SUNDRY NOTICES AND REPORTS ON WELLS (DO NOT USE THIS FORM FOR PROPOSALS TO DRILL OR TO DEEPEN OR PLUG BACK TO A DIFFERENT RESERVOIR. USE "APPLICATION FOR PERMIT" (FORM C-101) FOR SUCH PROPOSALS.)		WELL API NO. 30-025-33466

2. Name of Operator Armstrong Energy Corporation		6. State Oil & Gas Lease No.
3. Address of Operator PO Box 1973, Roswell, NM 88202		7. Lease Name or Unit Agreement Name SV Chipshot

SV Chipshot #1

Proposed Plugging Procedure

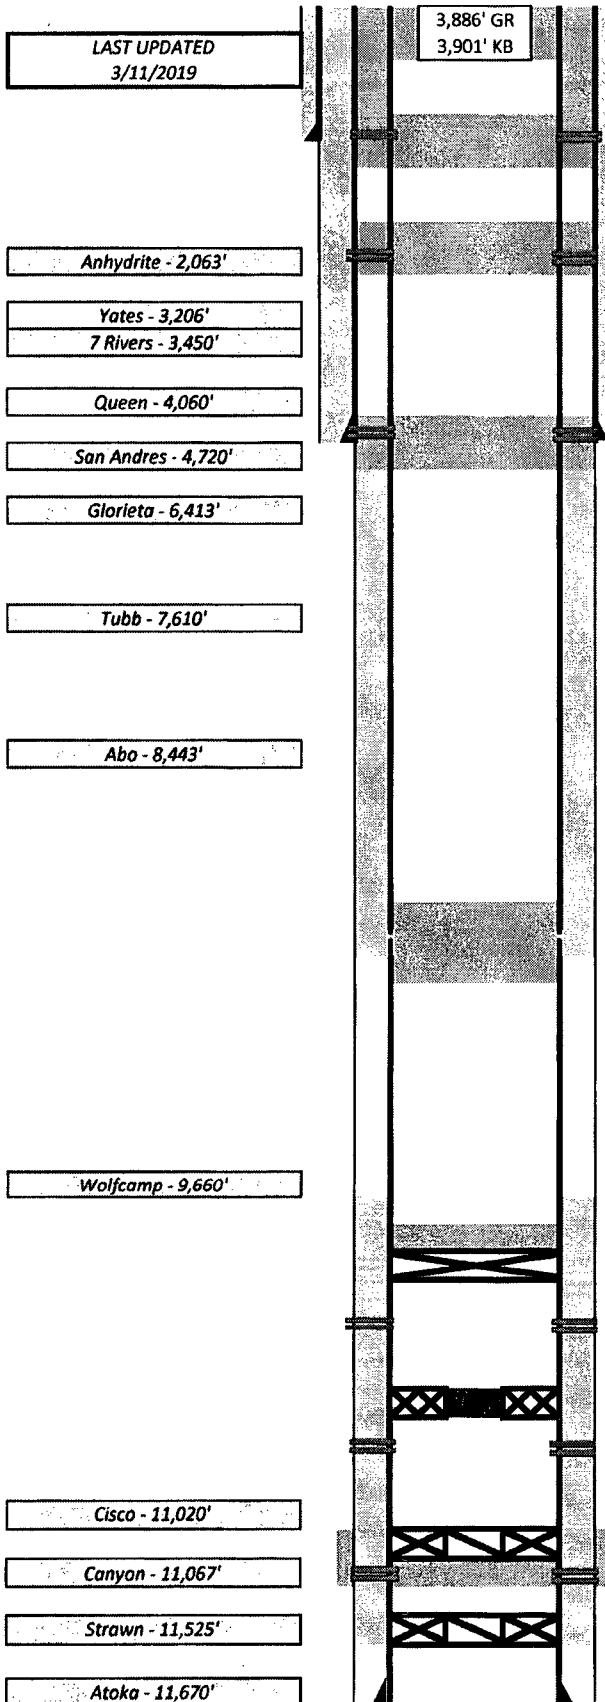
- 85 5x
- Set CIBP @ 10,550' w/ 85' class H cement cap, tag
 - Spot 25sx Class H across DV tool from 7,001' - 7,101'
 - Perf & squeeze 50sx Class C 4400'-4300' across intermediate shoe
 - Perf & squeeze 50sx Class C 2,000', top of salt
 - Perf & squeeze 50sx Class C 414' to surface across surface shoe
 - Cut off wellhead to verify cement to surface, install below ground marker.

P+S 50 SX 3300 base of salt

See Attached
Conditions of Approval
